Service Technical Information

MODEL NO.	AM-F70 / F65
SUBJECT	"Caution!" display appears.

REF.No. :G - 99 - 019 - E0

DATE :02. JUN. 1999

Fig. 1

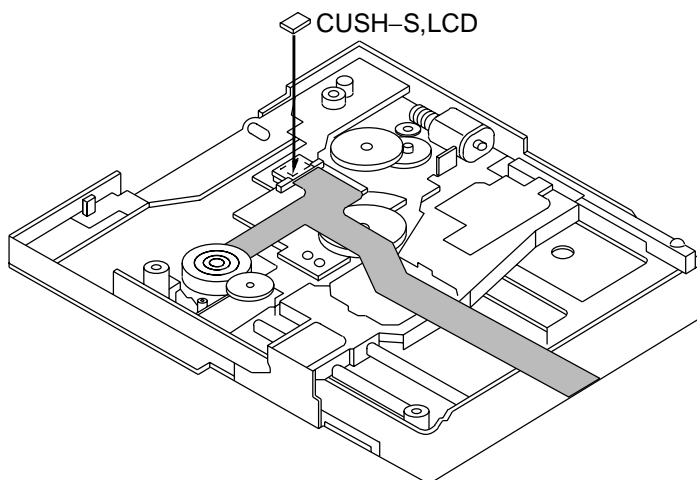
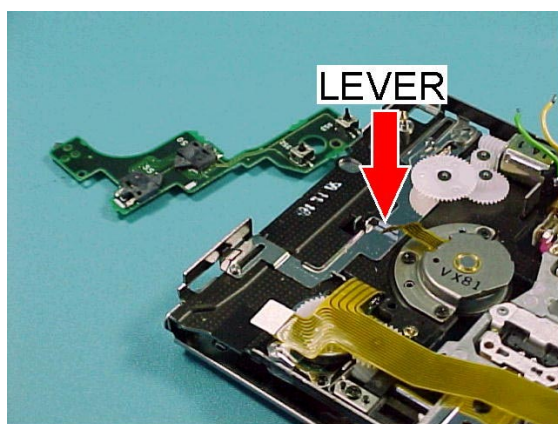
This symptom occurs when μ -COM fails to detect on/off of OWH UP(S50)/DOWN(S51) SW.

- If on/off detect of a switch fails even though the OWH position detect switch is pressed:
Replace the detection switch with new one.
- If the lever runs on to OWH UP SW(S50) (See Fig.1):
Remove the lever away from the switch, and then affix a cushion (CUSH-S, LCD) on to the connector of PWB, MECH (CN50).
